65EAE SERIES

65CNE/CME10 SERIES

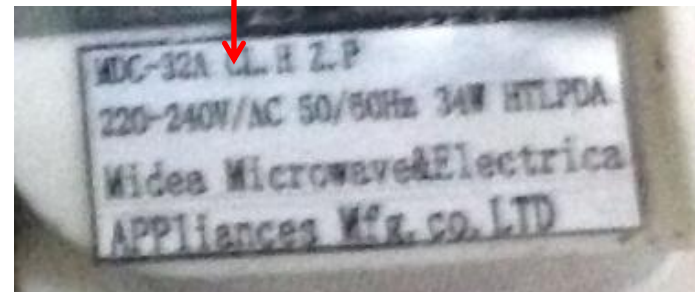
1. Replace the convection fan, change to higher speed one.

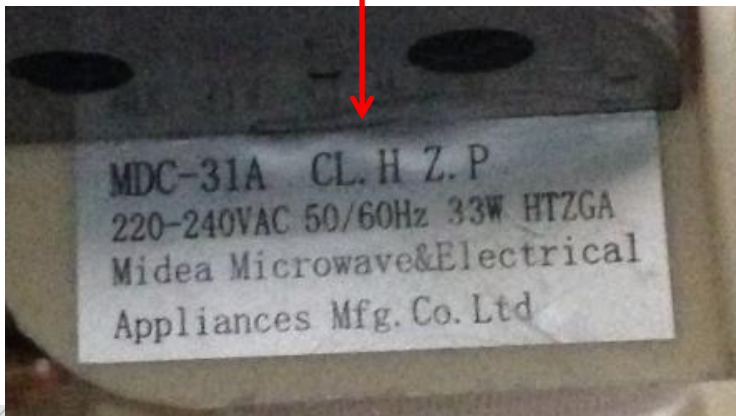
2.Modify the convection cover, different shape compare to before

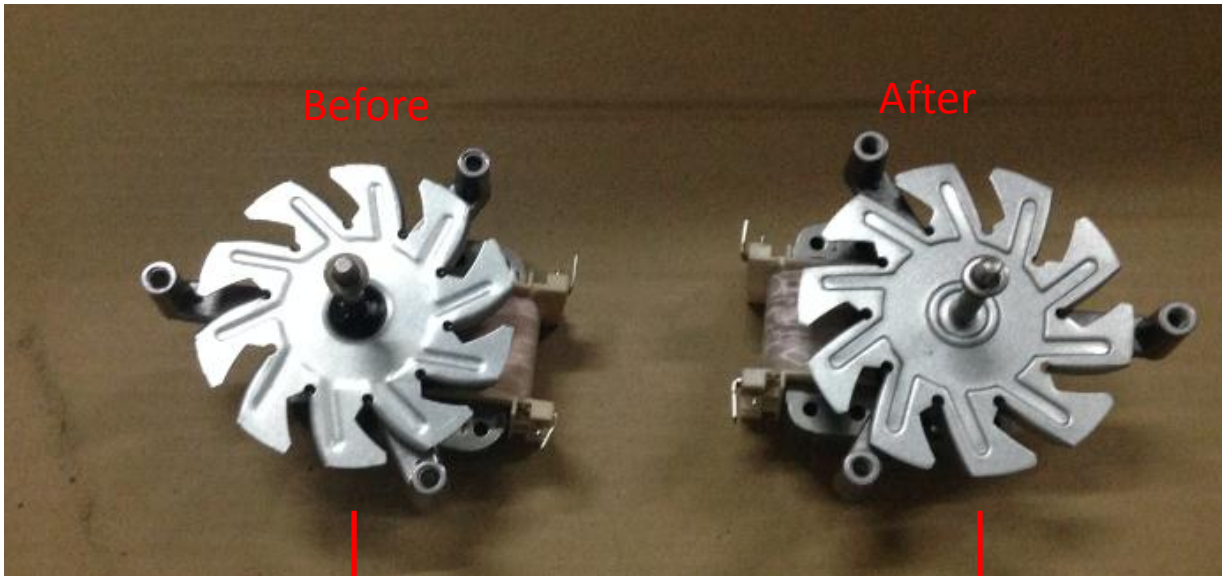
3.Increase the insulation foam thickness

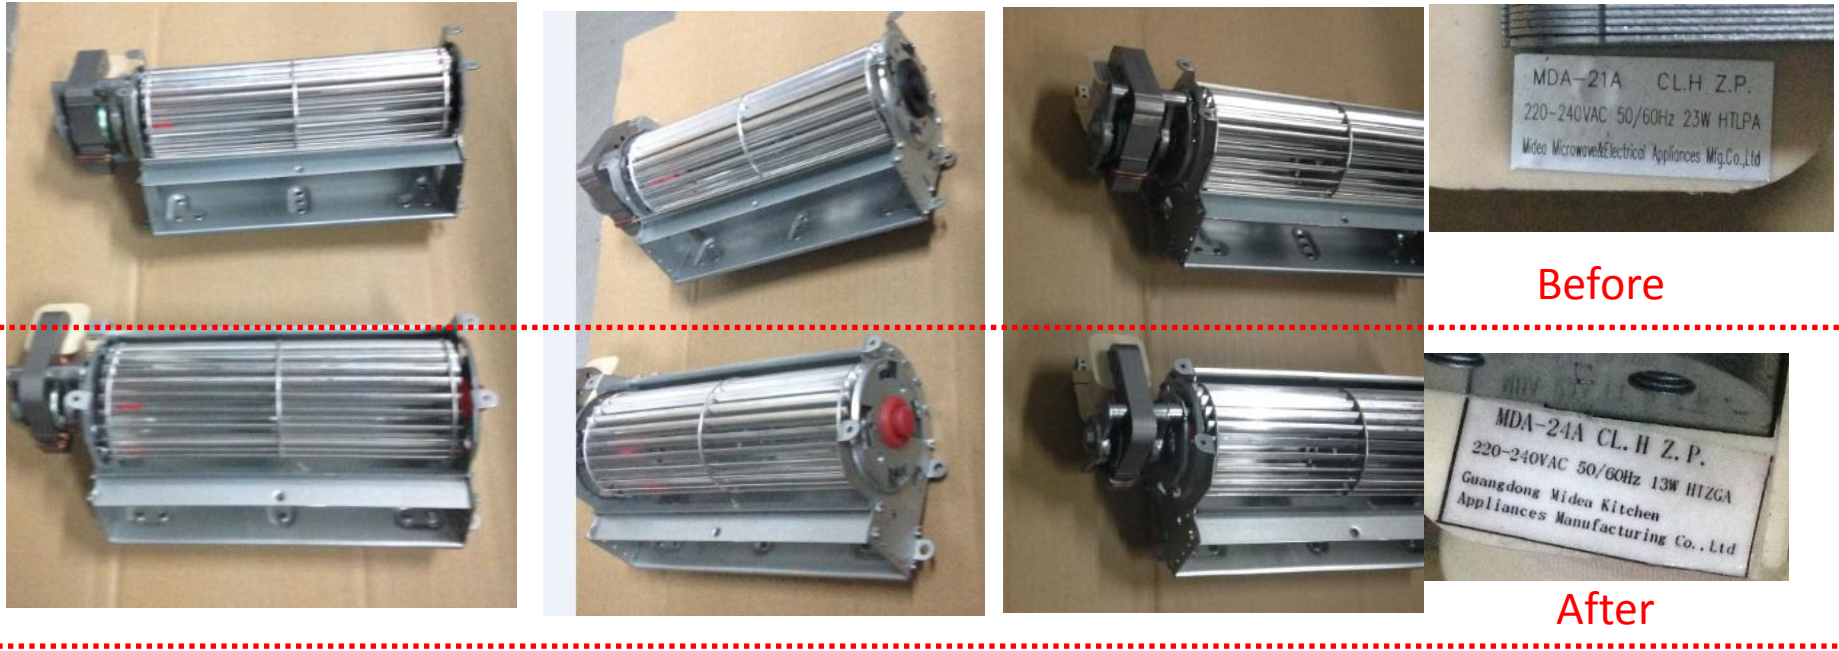
2. Replace the cavity seal, below is the new cavity seal
